Joseph M. Farley Nuclear Plant Units 1 and 2  
Bechtel Jobs 7597-011/021  
Electric Hydrogen Recombiner Splices -  
Justification for Continued Operation  
(PCR NO. 87-0-4441)  
Bechtel Files A-78, E-91  
AP-13525

SUBJECT: Evaluation of splices used on Hydrogen Recombiner heater leads to field cables.

ASSUMED IN RECOMBINER TERMINATION CONFIGURATION  
TYPICAL FOR 3 PHASES AND NEUTRAL

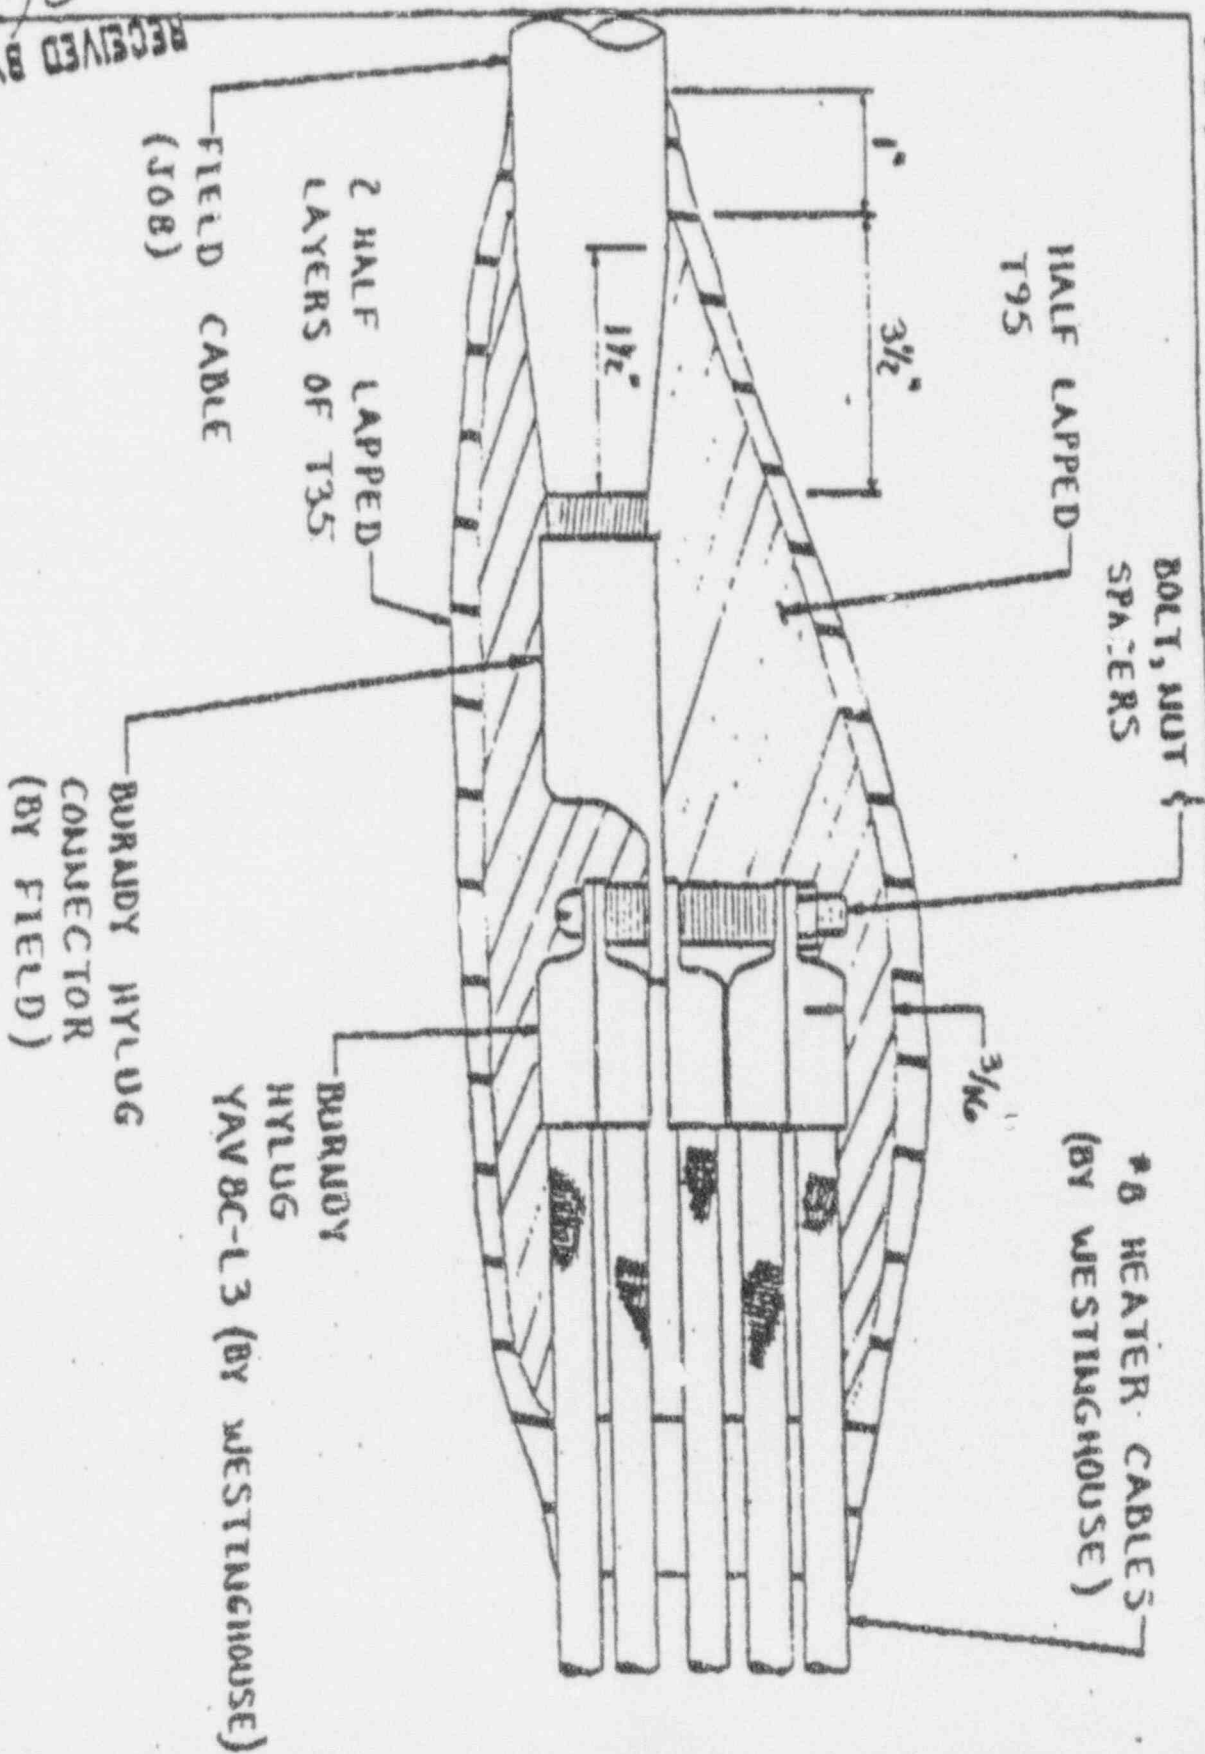
This evaluation assumes that the field cable to heater bank lead terminations have been made using a bolted lug connection which is insulated by Okonite T95/T35 tape materials. It is assumed that the existing thickness and splice overlaps are as shown on the sketch included as Appendix A.

The thickness of the T95 insulating tape installed per the attached Appendix A detail provides adequate phase to phase and phase to ground electrical insulating properties for 600 Volts service.

The splice configuration shown in Appendix A coupled with the qualification tests performed by Okonite provides reasonable assurance that this splice detail will perform its intended function in the relevant environments. Therefore, continued operation of Farley Nuclear Plant Units 1 and 2 is justified.
